## MCE TECHNICAL BULLETIN

Reference # 154

**Subject** Potential loss of motor control due to power supply failure, IMC-SCR.

**Equipment** IMC-SCR & IMC-Performa Controllers.

**Figure 1**

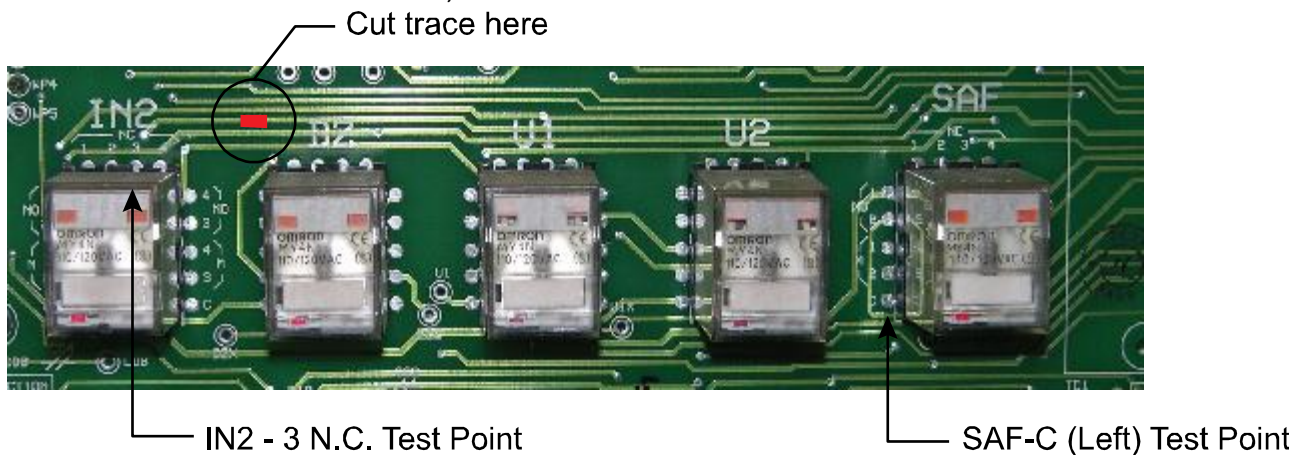
**Description** It has been brought to MCE's attention that if the voltage level of 5 volt power supply feeding the controller computer (swing panel) falls below regulation, it can have adverse effect on the operation of the motor control. In certain situations, the elevator computer may become inoperable and motor field voltage can drop to zero. Having very low or no motor field control can result in the car drifting in the direction of the load due to lack of torque control. **This scenario is only applicable to inspection operation.** Automatic and passenger operation use additional software monitors and are not affected.

**Action** Even though the likelihood of any such occurrence is unlikely, MCE recommends a hardware modification which eliminates the possibility of car being able to run on inspection when the computer is inoperable. Attached document explains the process of making a clad cut to the HC-RB4-SCRI-(x). Clad cut removes the ground connection to the SAF relay on the HC-RB4-SCRI-(X) thru relay IN2 N.C. #3 contact. Please perform the outlined modification with extreme care and make sure no other traces are altered in the process. Contact MCE support team for any further questions.

1. Power down the controller.
2. Using the resistance setting on a digital multimeter, confirm there is continuity between IN2-3 N.C. and the left-hand coil connection on the SAF relay using the relay test pads, which you can see in Figure 1 below.
3. With power still off to the controller, locate the trace that connects to the via just above the IN2-3 N.C. contact on the HC-RB4-SCRI-C board, and make a clean cut on that trace as indicated below:

4. Confirm that there is no continuity between the two points measured in Step #2 above.
